## Product Change Notice (PCN)

PCN Number: **PCN-0451112R-01**

Product(s) Affected: **PJ-017DH**

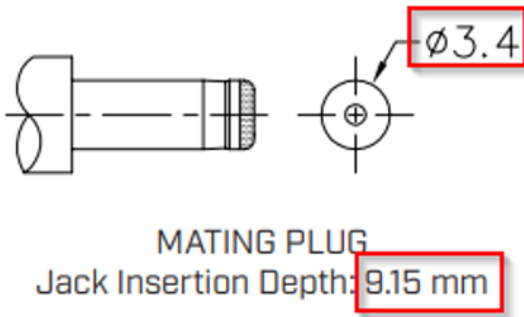
Description of Change: **Minor Housing and footprint differences. Material Change on the housing and terminals. See image Below**

PREVIOUS CUI DEVICES DETAIL / IMAGE			NEW CUI DEVICES DETAIL / IMAGE		
	MATERIAL	PLATING		DESCRIPTION	PLATING/COLOR
center pin	copper	nickel		center pin	brass
terminal 1	brass	silver		terminal 1	brass t=0.40
terminal 2	copper alloy	silver		terminal 2	bronze t=0.30
terminal 3	brass	silver		terminal 3	brass t=0.40
plastic	PBT			cover	PA9T [UL94V-0]
				housing	PA9T [UL94V-0]

MATING PLUG  
Jack Insertion Depth: 9.15 mm

MATING PLUG  
Jack Insertion Depth: 8.7 mm
